Westfield City Council Report

Petition Number:	1505-PUD-07
Petitioner:	Site Solutions Property Group, LLC
Request:	A change of zoning from the AG-SF1: Agriculture / Single-Family Rural District to the Lantern Park Planned Unit Development (PUD) District.
Current Zoning:	AG-SF1: Agriculture / Single-Family Rural District
Current Land Use:	Agricultural/Unimproved
Approximate Acreage:	40.95 acres +/-
Exhibits:	<ol style="list-style-type: none">1. Staff Report2. Location Map3. Concept Plan Comparison4. PUD Ordinance5. Neighbor Meeting Summary6. Petitioner's Narrative7. Public Comments8. APC Certification
Staff Reviewer:	Pam Howard, Associate Planner

EXHIBIT B
CONCEPT PLAN

EXHIBIT 1D
LANTERN PARK
CONCEPT PLAN
60 LOT MAXIMUM
WESTFIELD, INDIANA
JUNE 2, 2015

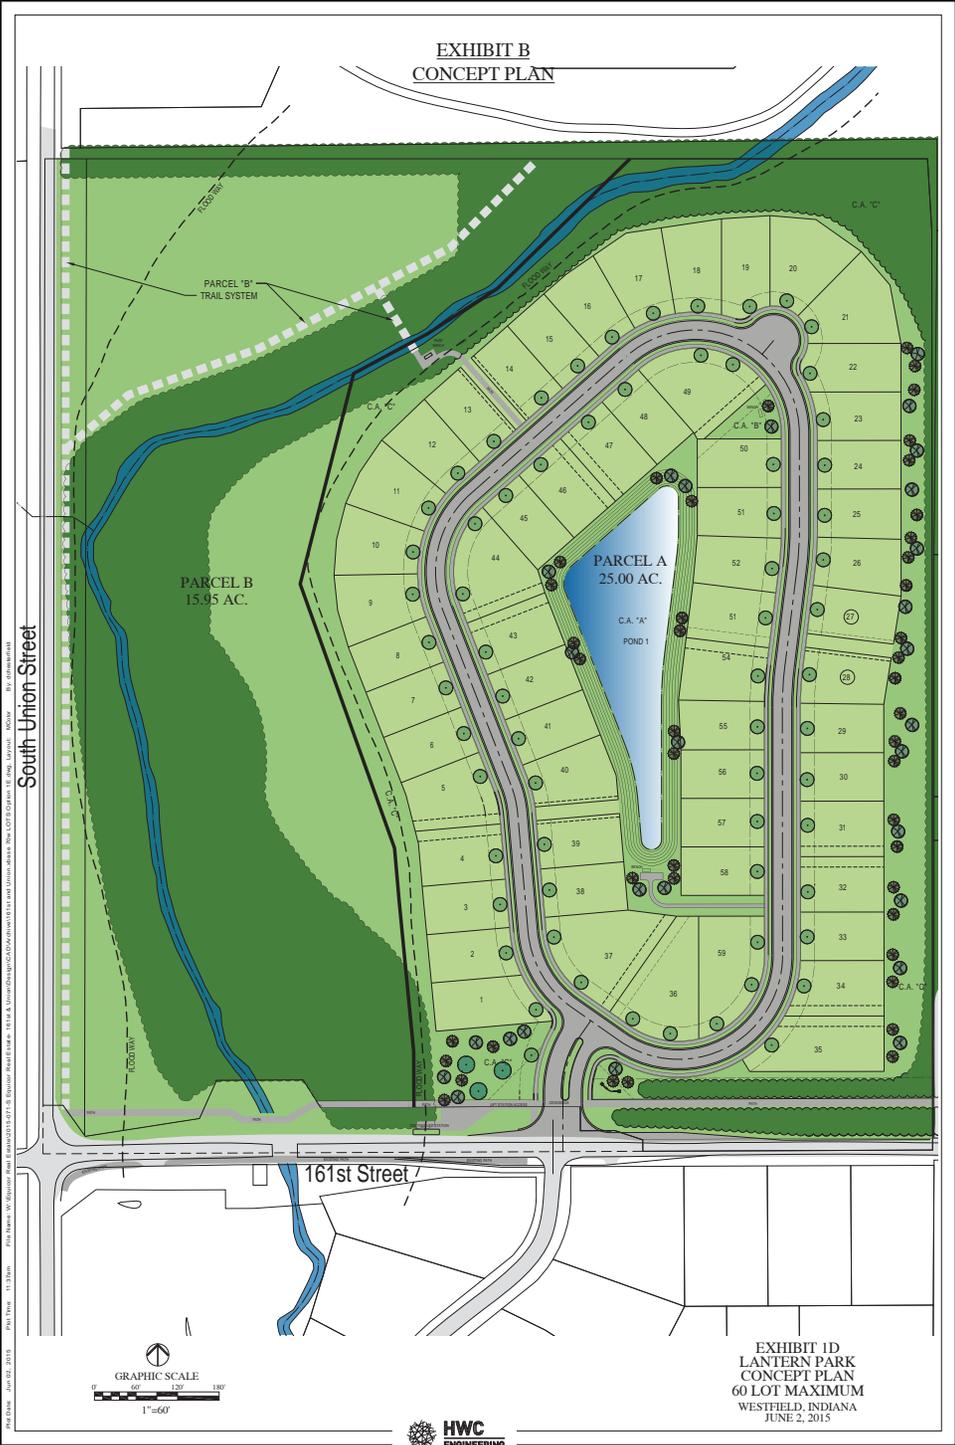
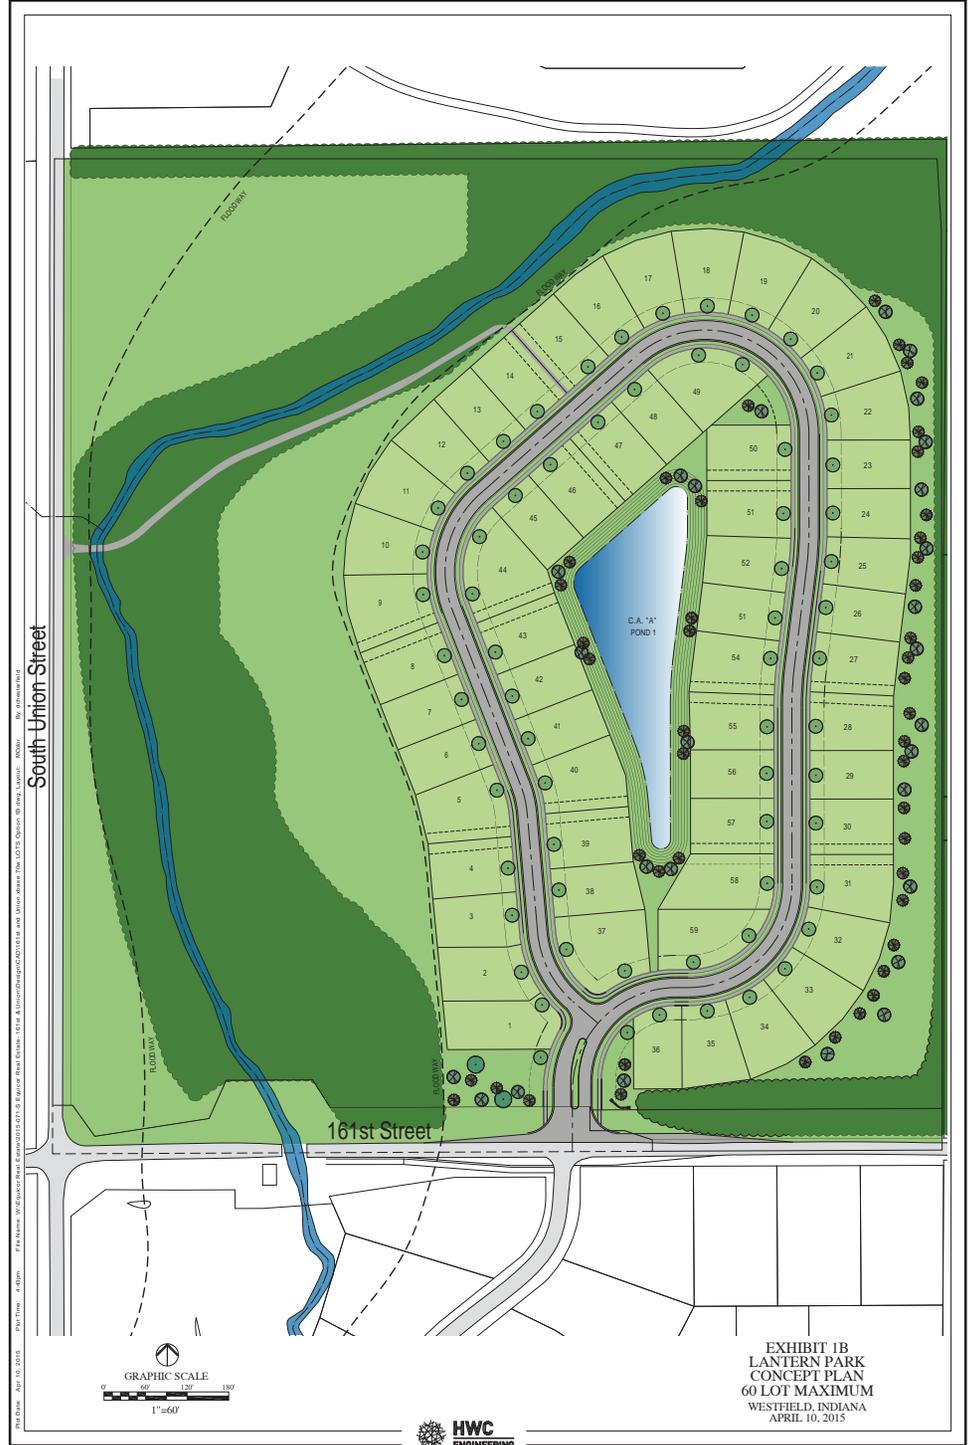
1. Section 5.2 should include the statement “No homes shall be built on Parcel B.”
2. The trails on Parcel B should be referred to as “Parcel B Trail System” as opposed to “Trail System to be constructed with Parcel B.” This should be modified on both the Concept Plan and in Section 10.2.

Concept plan still says path on Union to be installed with parcel B but ordinance specifies to complete with final phase of A.

These revisions have been incorporated into the PUD Ordinance, as presented (see **Exhibit 4**).

10.2 Parcel B: All requisite public improvements on Parcel B (including but not limited to the Perimeter Path on Union Street and the path noted on the Concept Plan as “Parcel B Trail System”) shall be installed with the final phase of Parcel A, unless otherwise determined by the Director. Notwithstanding any other provision herein, any trail located on Parcel B (including the trail noted on the Concept Plan as “Parcel B Trail System”) must be hard surfaced and installed according to current City of Westfield standards for trails.
